CALIFORNIA SOLAR ENERGY INDUSTRIES ASSOCIATION

COMMENTS ON THE CEC PROPOSED SB1 ELIGIBILITY GUIDELINES

Docket No. 07-SB-1X

October 1, 2008

NSHP Manual Method of Determining Shading

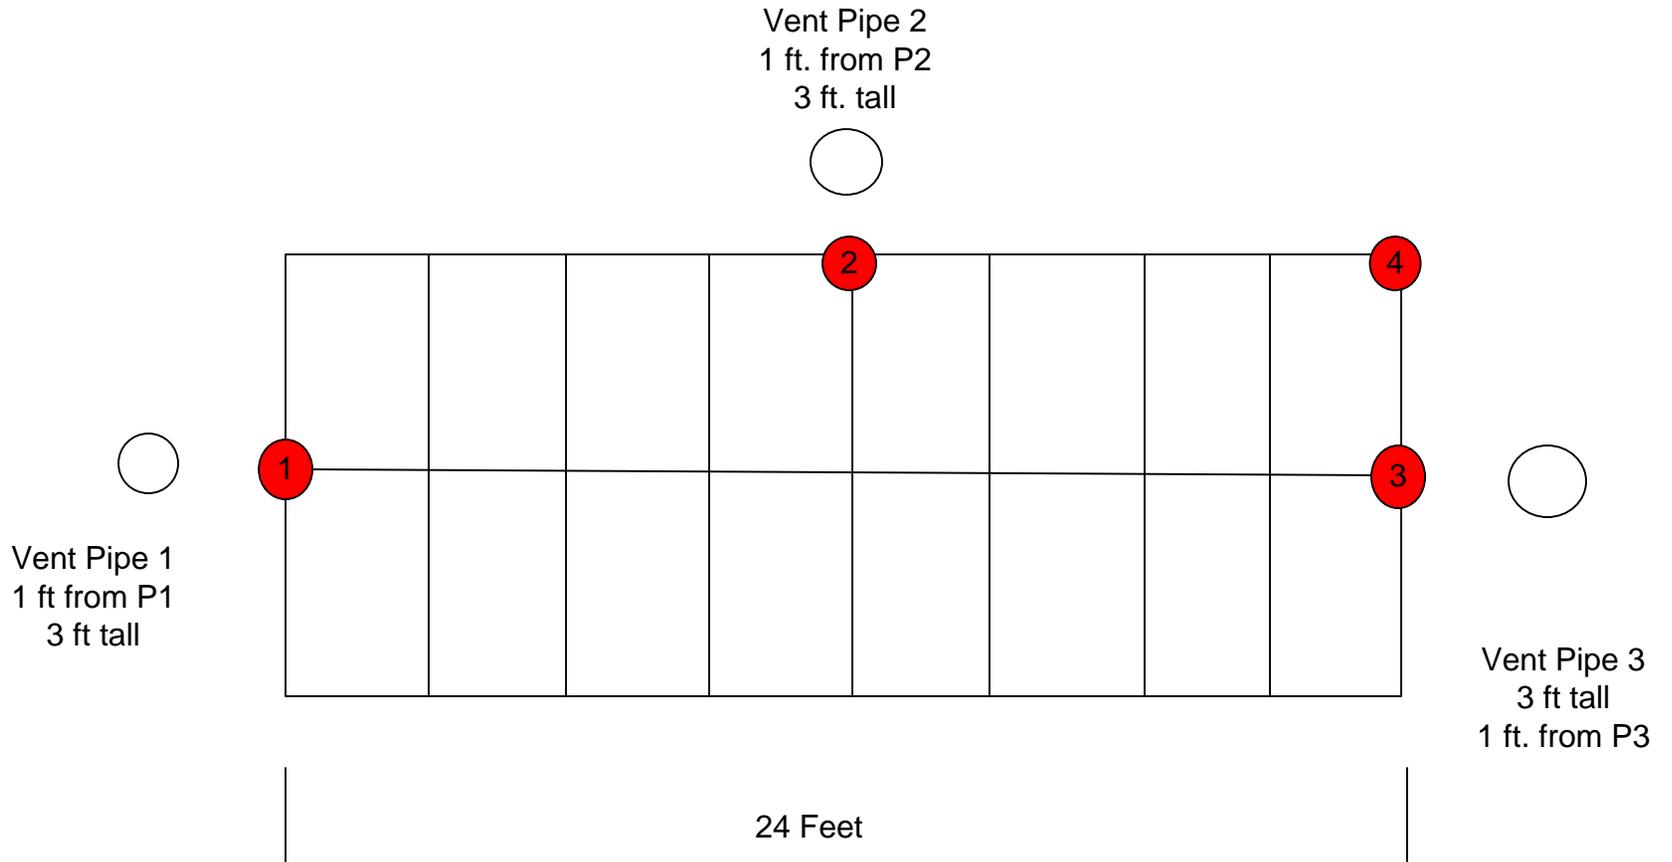
If each vent pipe is 1' from the array, we need to determine the points onto which each vent pipe and/or tree causes the worst shading.

Therefore, I am going to choose point 1 for Vent Pipe 1, point 2 for vent pipe 2 and point 3 for vent pipe 3 and point 4 for Tree number 1.

For Automatic Studies such as using the Solmetric Suneye, We will take 4 shading studies from the 4 points and show the affect of each of the obstructions

Rebate Range Cost \$ 2,852.00
Rebate Range kWh Production 1976
Summary Manual is by far the most difficult shading study to accomplish and the most punitive
Obstruction to P4 makes the most sense for worst shading because of the tree
Obstruction to P4 provides the best shading Rebate.

For actual field work, there is far too much variation due to the fact that the person doing the shading Study has to determine which point has the worst shading

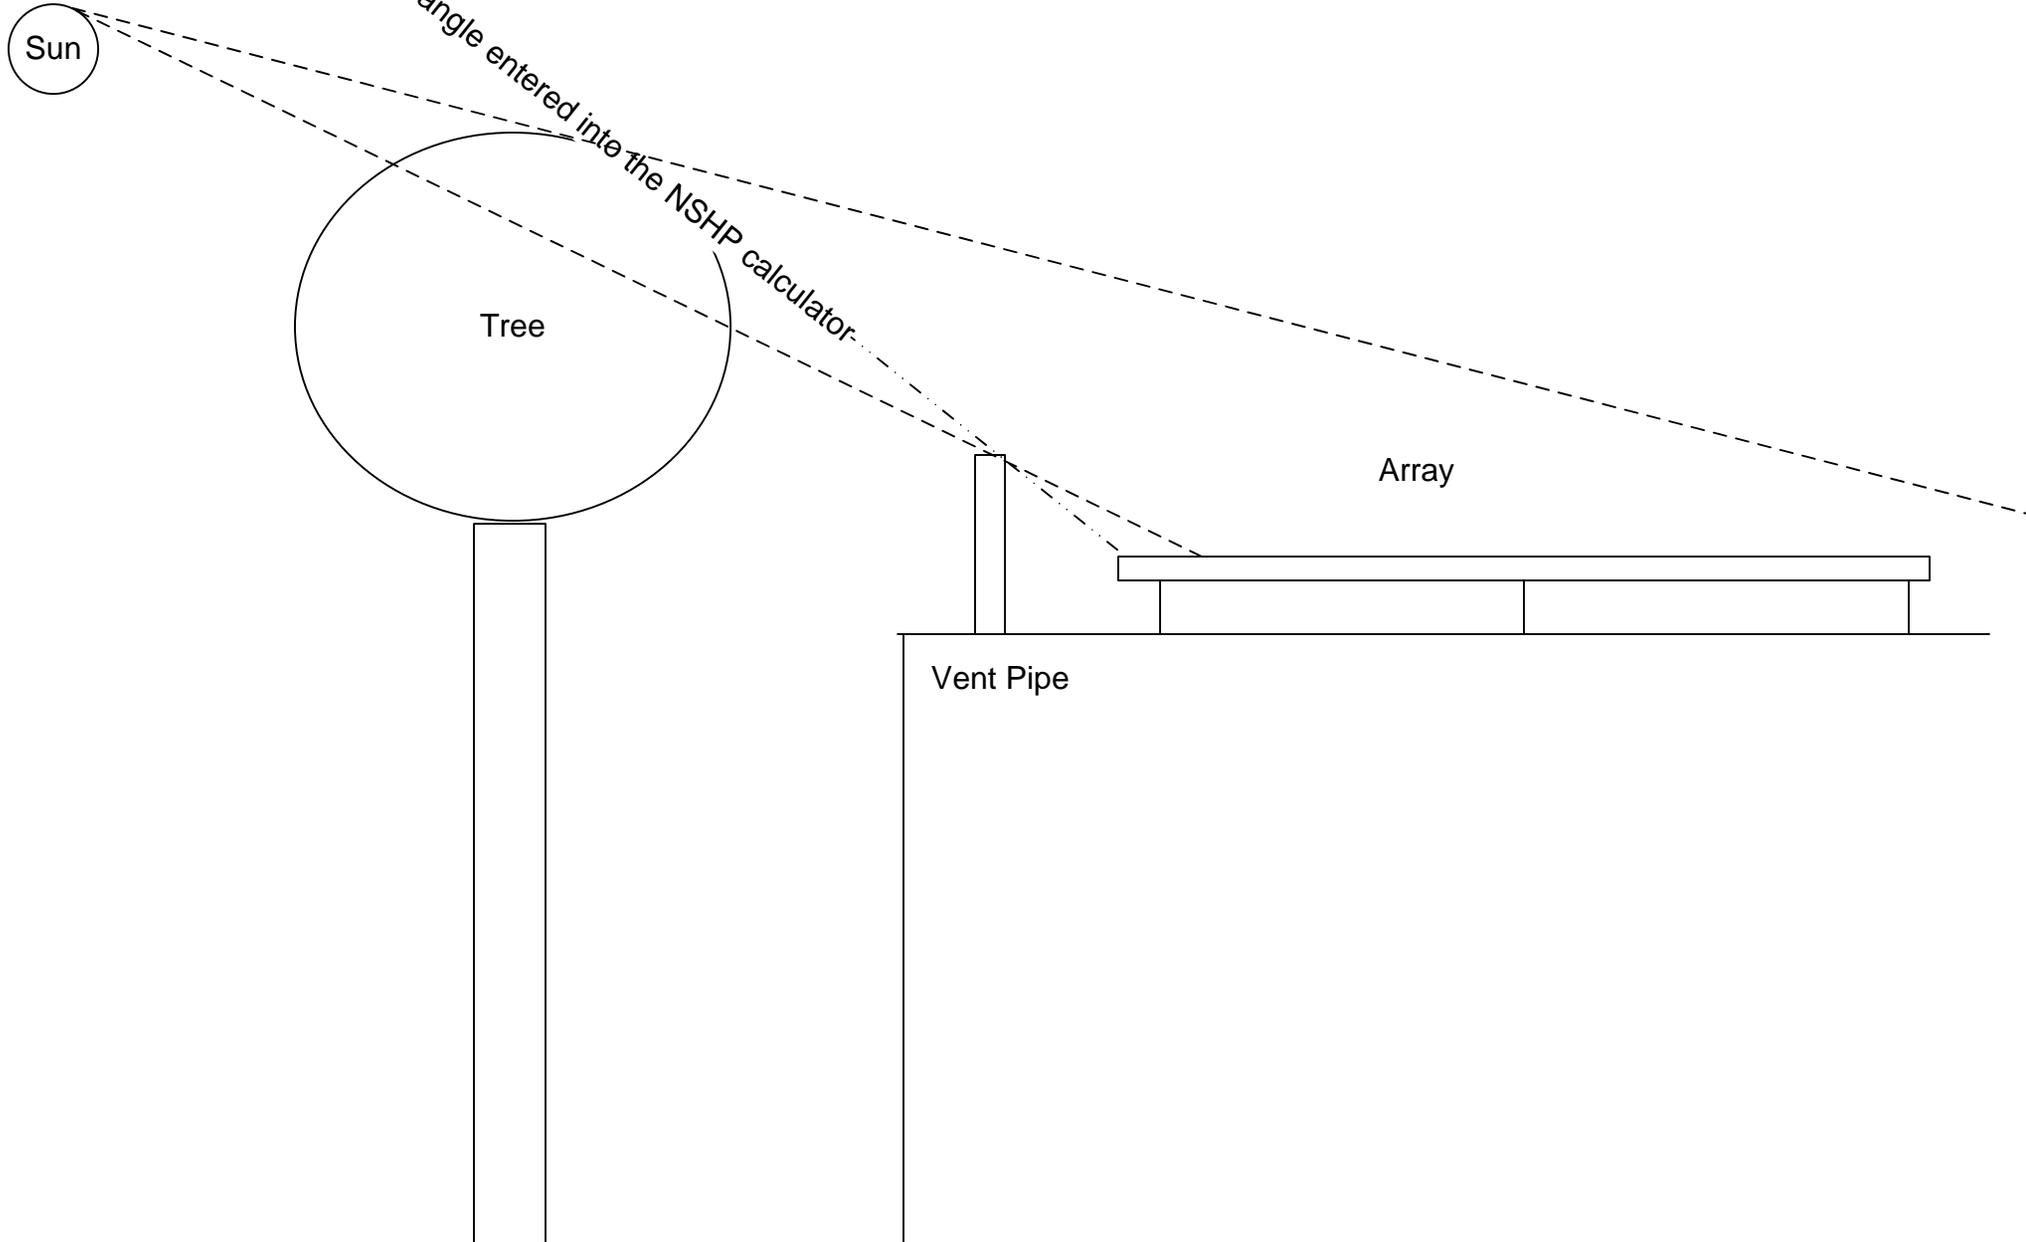
Which causes more shading, the tree or the vent pipe.
CSI reasonably predicts shading.
NSHP does not as it treats them both the same as an angle to the
array
